Executive Hi-Fashions LTD (Extension)

15 January 2024

2. Observations

Observation 1: Lack of information in as-built drawings and missing Architectural drawings (Shed 1-Cutting Shed).

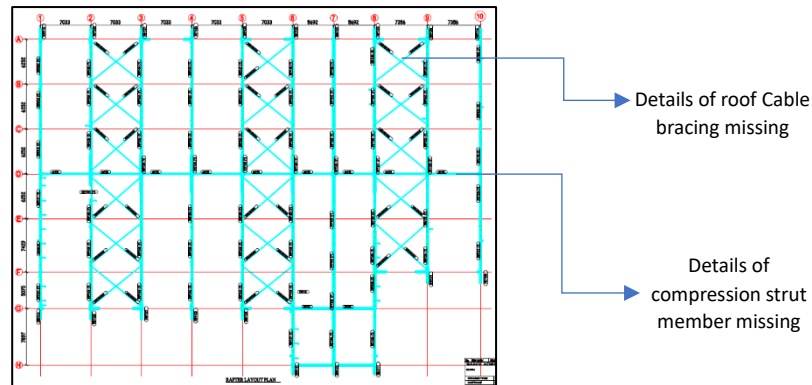
Description: During the inspection, cable bracing and compression strut member details information was missing in the as-built drawings. The building engineer is required to survey the full structure and produce accurate as-built drawings with full information on cable bracing and compression strut members.

Observation 2: The design report needs to be reviewed (Shed 1-Cutting Shed).

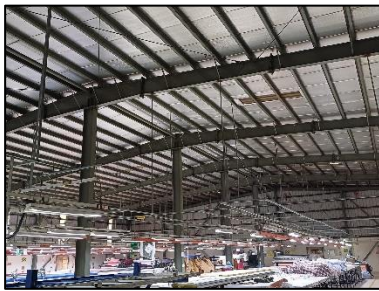
Description: The design report needs to be reviewed by RSC for lateral forces. The building engineer is required to submit the design report and necessary documents to RSC for review.
